Product Change Notification

TE Connectivity

Product Change Notification: E-17-003750

DEUTSCH DT2pin and 3pin Plug and Receptacles Global Footprint Initiative (No Cap)

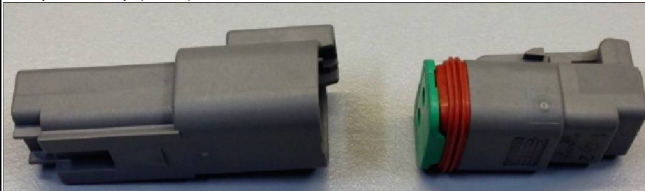
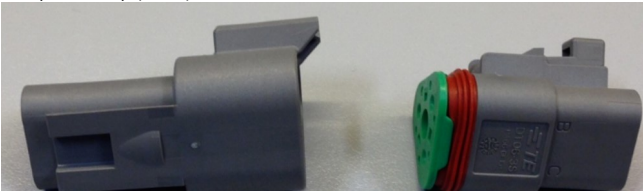
The Industrial and Commercial Transportation (ICT) business unit of TE Connectivity (TEC) will be adding to existing North America (NA) based footprint for standard DEUTSCH DT 2pin and 3pin plug and receptacle connectors. Footprint additions are: TEC Suzhou (China) and TEC Empalme, SON (Mexico). Production location will be based on product type for connectors with or without rear caps. All manufacturing plants are ISO/TS 16949 certified. Also, part of this initiative will be some design changes. Plug front seals will use seal retention version, improved product marking and date coding. Legacy DEUTSCH part numbers remain same, PN revision change only, raw material-color remain same, interchangeable and backwards compatible. Box package will change to use standard automotive AIAG compliant box size. See attached presentation and product drawings for more information.
